PREVOST

**WARRANTY
BULLETIN**

WB13-29

DATE :	MAY 2013	SECTION :	05 - Cooling
EXPIRATION:	MAY 2015		
SUBJECT :	LOOSENING BOLT ISSUE - COOLING FAN CLUTCH TRIPOD

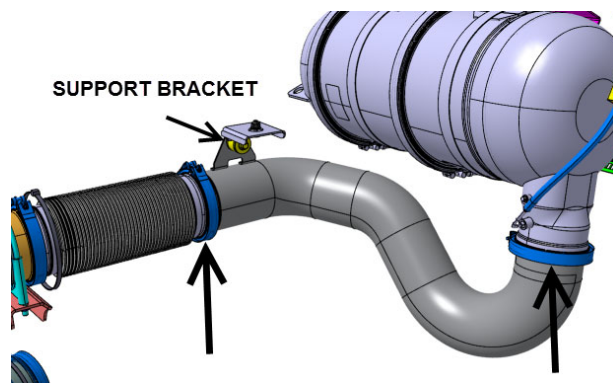
b. Undo the two (2) V-band clamps identified on the image.

c. Unscrew the nut at the support bracket.

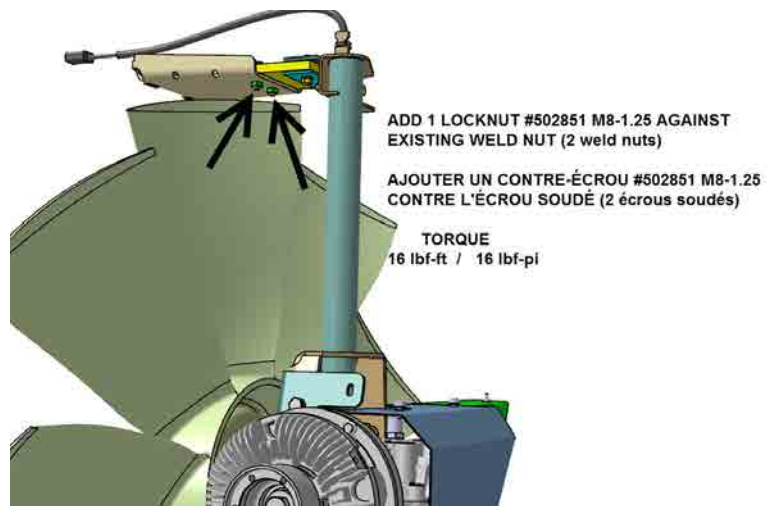
4. **ALL TYPES.** Add two locknuts #502851 as described on the image at right. **If needed, tighten the bolt a little bit more to show more threads.**

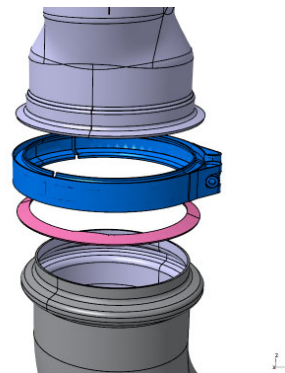
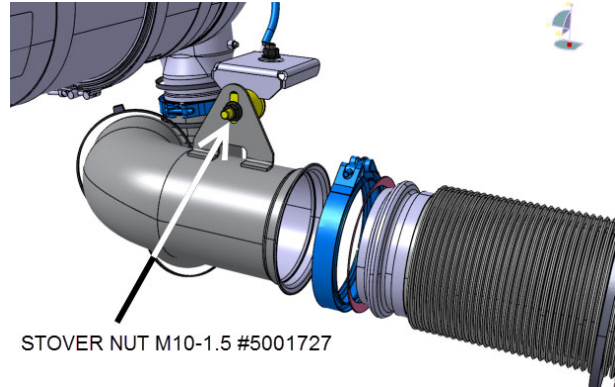
5. **ALL TYPES.** Add two locknuts #502851 as described on the image at right. **If needed, tighten the bolt a little bit more to show more threads.**

- 2 new exhaust gasket #21095726
- 2 new V-band clamps #21021850 (torque 100 lbf-inch)
- 1 new Stover nut M10-1.5 #5001727 (torque 32 lbf-ft)
